## PLANNING AND ZONING BOARD STAFF REPORT

### The Link

Meeting	File No.	Application Type
May 19, 2025	2024-228-SPR-LV3	Architectural Style
Property Owner		Agent
Downtown Sixth Avenue, LLC		Bonnie Miskel Esq. and Christina Bilenki Esq. of Miskel Backman, LLP

Provide a recommendation to the City Commission regarding the implementation of the Masonry Modern architectural style within the Central Business District (CBD), pursuant to **LDR Section 4.4.13(F)(3)(e), Appropriate Architectural Styles**.

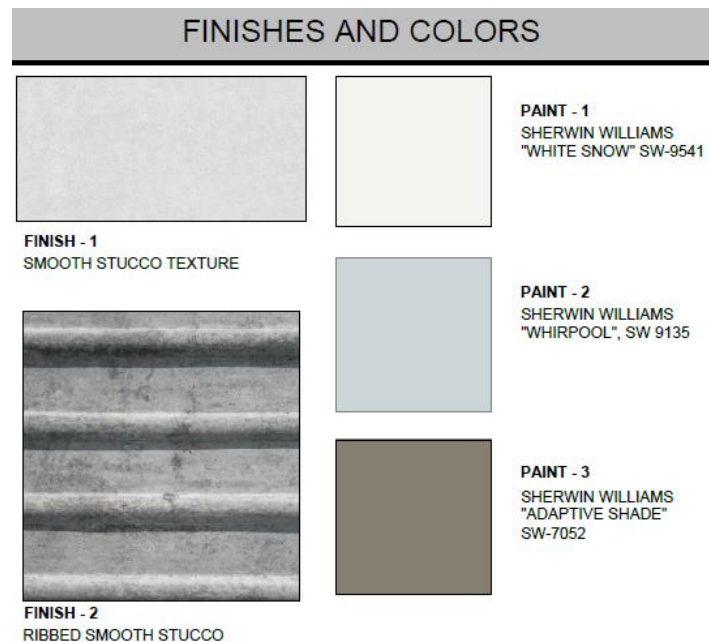
- **Massing and Facade Composition:** The **east and south facades** benefit from modulation in depth and rhythm. Window recesses, vertical alignment, and framed balcony openings contribute to a dynamic expression of mass. These features reflect the Masonry Modern aesthetic, which relies on light and shadow interplay rather than applied ornament. Conversely, the **north facade is notably unarticulated**, with an expansive stucco plane devoid of fenestration or material relief. This facade lacks both functional and visual permeability. Staff acknowledges the applicant's response regarding privacy and internal design needs but notes that other projects have achieved more thoughtful architectural resolution of these constraints, including the use of vertical scoring, or screened openings.

- **Architectural Elements:** Masonry Modern design often incorporates balconies, cantilevers, eyebrows, or structural overhangs to animate the form and provide practical environmental benefits such as shading and passive cooling. These are largely absent in the proposed design, weakening the architectural rhythm and limiting opportunities for indoor-outdoor living typically sought in the urban fabric of Delray Beach.

- **Materials and Detail:** The material palette includes predominantly stucco finishes with wood accents but lacks the textured or patterned masonry and layered material treatment typically expected of Masonry Modern architecture. The absence of contrasting elements or subtle ornamentation makes several facades feel flat and uniform. This is especially notable on the north facade, which appears as an impenetrable mass rather than an integrated part of a vibrant, pedestrian oriented downtown.

- **Roofline:** The parapet treatment is minimal, and while this may align with the style restraint of Masonry Modern, it contributes to a static roofline that lacks visual interest. Similarly, the corners of the building, critical areas for articulation, are treated as abrupt terminations rather than opportunities for design expression or relief.

- **Corner Treatment and Urban Identity:** At the intersection of NE 6th Avenue and NE 2nd Street, the building occupies a prominent corner within the CBD. While the massing turns the corner, the treatment remains plain, lacking the architectural punctuation often associated with signature corners in urban contexts. Introducing angled volumes, projecting balconies, or material wraps at this junction may yield a more expressive presence and frame the building's civic role more clearly.

- **Ground-Level Design and Entry Definition:** Ground-level design features, such as planter integration, recessed entrances, and storefront-type glazing, introduce a soft threshold between public and private realms. The main pedestrian entry along NE 6th Avenue, however, is only modestly marked. More pronounced spatial or material transitions could help emphasize the building's point of arrival and reinforce its role in defining the urban edge.

- **Environmental Considerations:** From a sustainability standpoint, the north facade presents an "environmental irony." By eliminating glazing on the cooler side of the building, the design increases reliance on artificial lighting, undermining potential daylighting benefits and creating functional imbalance. A more even distribution of openings would better align with both environmental performance and aesthetic coherence.

- **CBD Contextual Fit:** The Central Core Sub-district aims to foster a walkable, mixed-use downtown that respects Delray Beach's historic moderate scale. While the project's massing is generally compatible with adjacent structures, the rigidity of certain facades and limited articulation may limit its ability to reinforce the desired "Village by the Sea" character. A more nuanced treatment of detailing, particularly along pedestrian edges, would enhance the building's contribution to the district's identity.
